Planning Application Ref: M/17/20/T

Location: Builders Yard, 17 Harefield Road, Ancton, Middleton-On-Sea, PO22 6EE

Description of works: Crown lift to approx. 6m, reduce back to first leader lowest limb to south over entrance drive, reduce mid crown back by 3m, upper crown by 2.5m and height by 2m to 1no. sycamore tree

Figure 2 Positions of final cuts

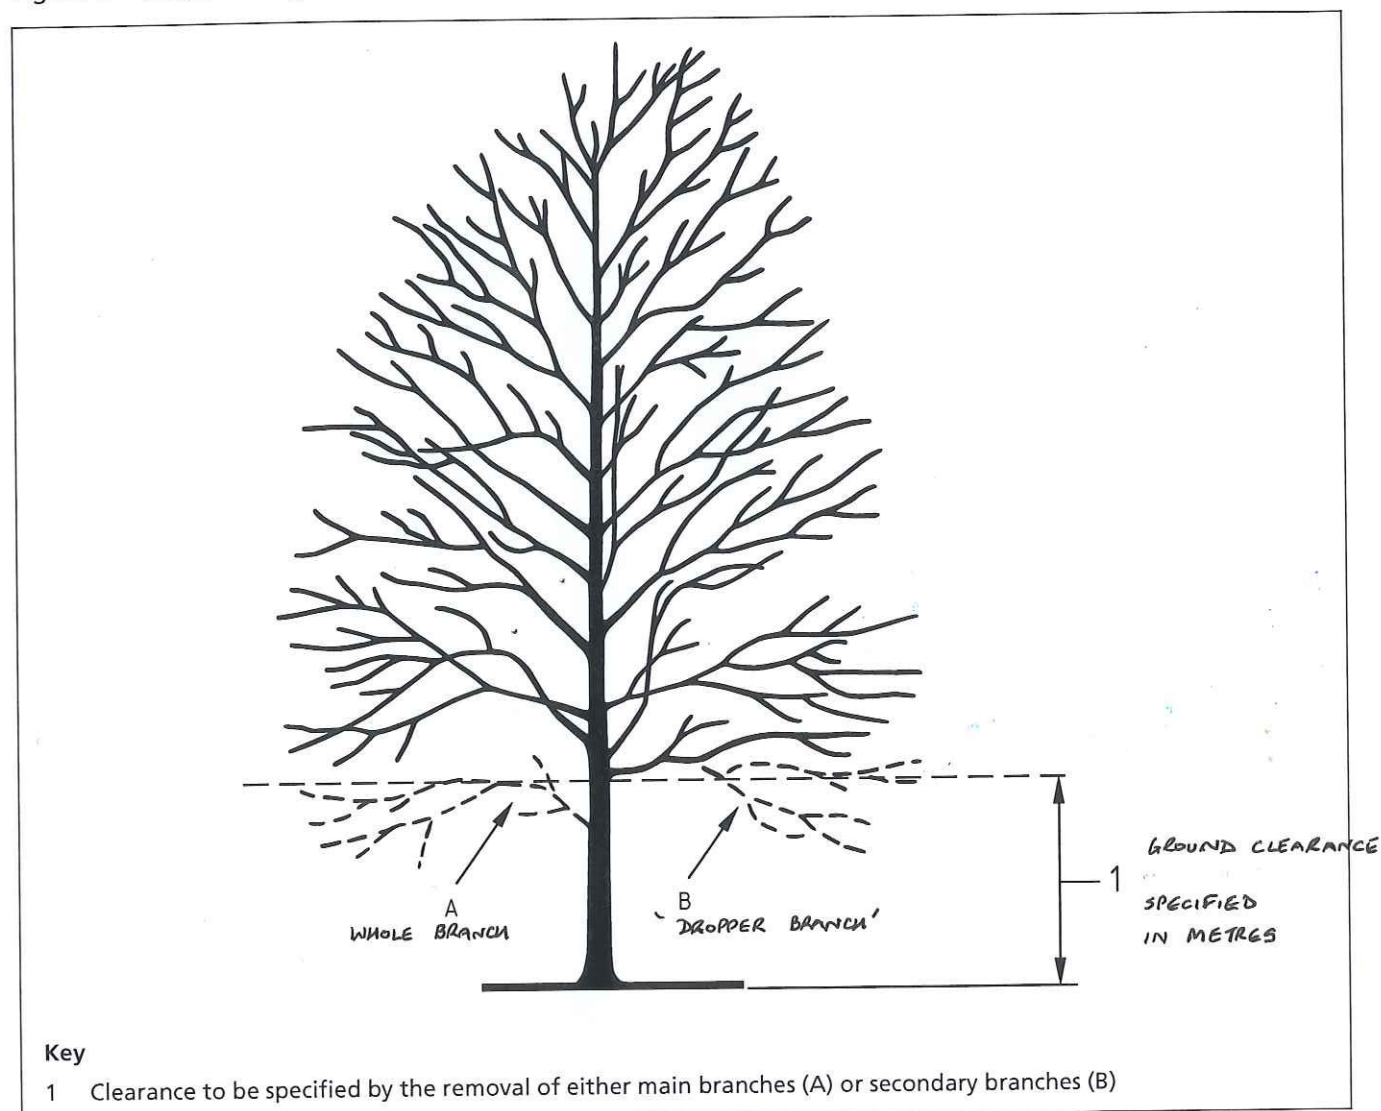
- Part a) Where whole branches are to be removed and final cuts made close to the trunk or branch union they are to be made as shown in Figure 2 of BS3998:2010
- Part b) Where branches are to be shortened back the final cuts are to be made at the correct angle shown in BS3998:2010 and adjacent to a live bud or lateral.
